Duane W. Bollig
Project Coordinator
Minerals Department

July 13, 1982

RE: Sand Rock Mill Project - Docket No. 40-8743 - Responses to NRC Request (dated November 3, 1982) for Additional Geohydrology Data

FIGURE A. SCHEMATIC SKETCH OF PIT 36N AFTER RECLAMATION

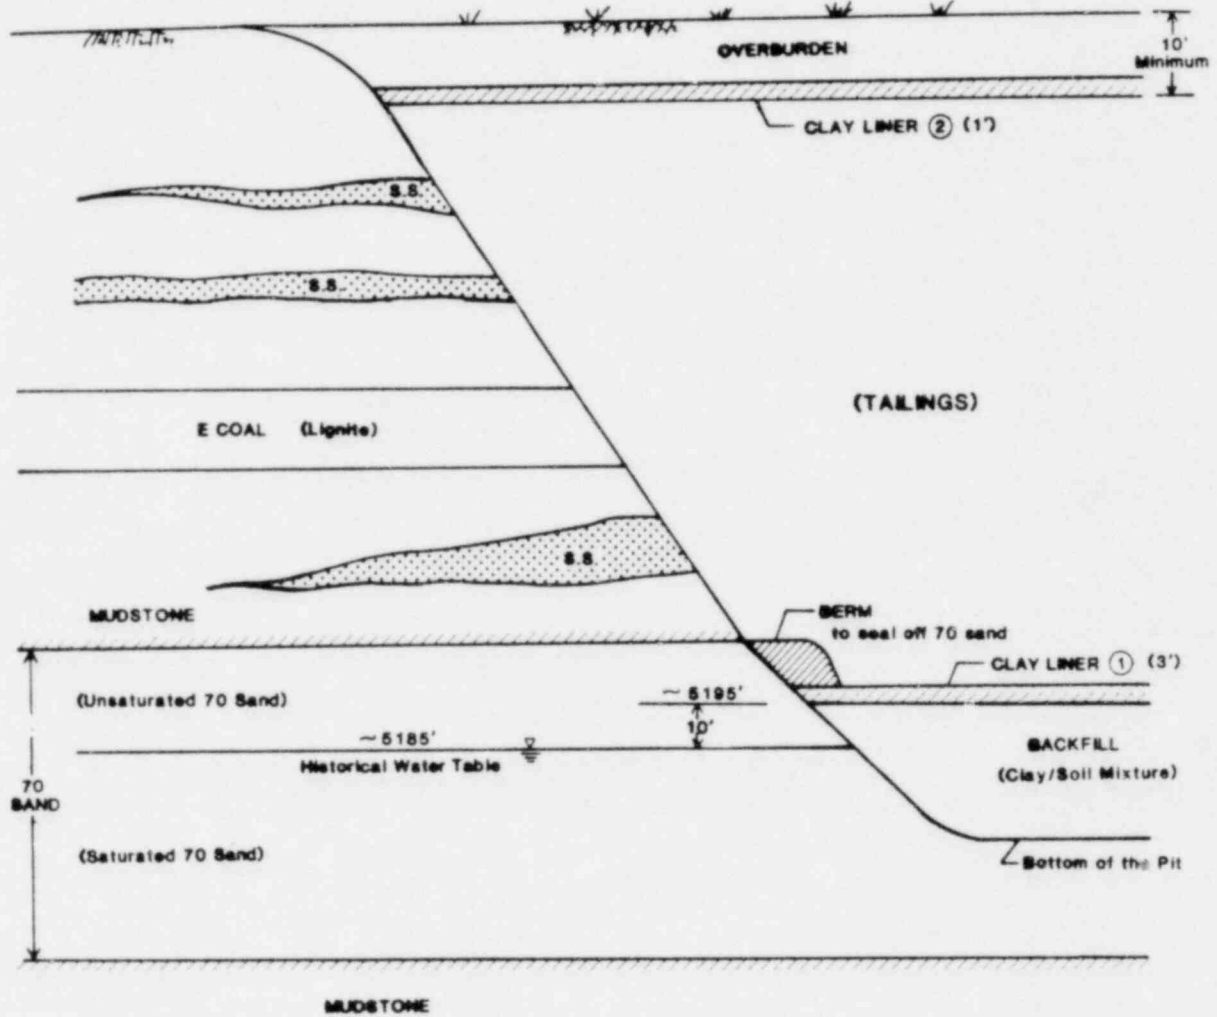
- (2) No flow would move downstream through the downstream side of the pit surface but would seep through the clay liner at the bottom of the pit:

A 3'-thick clay liner has been proposed to separate the tailings from the backfill materials at the bottom of the pit (see Figure A, attached). The top of the ore zone backfill will be at least 10' above the historical water level in the 70 sand.

Therefore an unsaturated zone of about 10 ft would exist between the bottom of the clay liner and the water table in the 70 sand (or in the backfill).

The surface area of this clay liner is approximately $1.6 \times 10^6 \text{ ft}^2$ and the hydraulic conductivity of the clay has been estimated as 0.14 ft/yr.

The water head build-up required to produce a vertical percolation rate of 9,244 ft^3/yr (0.13 gpm) through the clay liner can be estimated as follow:

$$9,244 \text{ ft}^3/\text{yr} = 0.14 \text{ ft/yr} \times h \text{ ft} / 3 \text{ ft} \times 1.6 \times 10^6 \text{ ft}^2$$

$$\text{or } h = \frac{9,244 \times 3}{0.14 \times 1.6 \times 10^6} = 0.12 \text{ ft}$$

The results from both cases indicate that the average buildup of water in the tailings would be insignificantly small.
